URGENT Field Safety Notice

Multiva 1.5T systems Terminal connections in the general Mains Distribution Unit (g-MDU) may produce a Thermal Event

30-May-2024

Figure 1. Hotspot on terminal connection of g-MDU

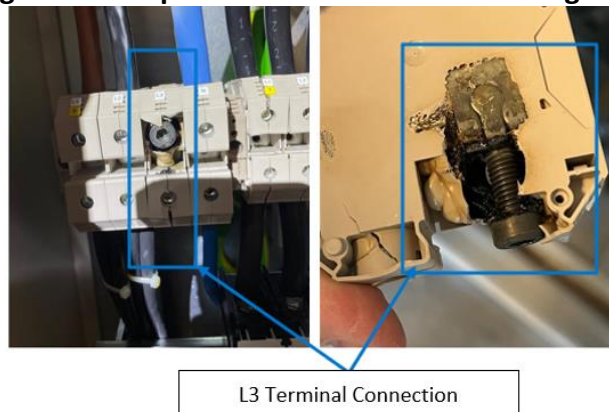
Philips has identified an issue where the g-MDU (global Mains Distribution Unit) L3 terminal connection may become loose creating a hotspot (see figure 1) that may cause smoke/fire to alarm in the hospital's technical room. The g-MDU, located in the technical room, is the single-entry point for the hospital electricity supply and distributes the electricity toward the various cabinets and components of the MR Scanner.

Philips will contact you to schedule time for a Field Service Engineer (FSE) to visit your site to inspect the g-MDU connections in the technical room and apply the proper torque to the connection if necessary. (reference FC078100583). Philips plans to start implementing corrections in July 2024.
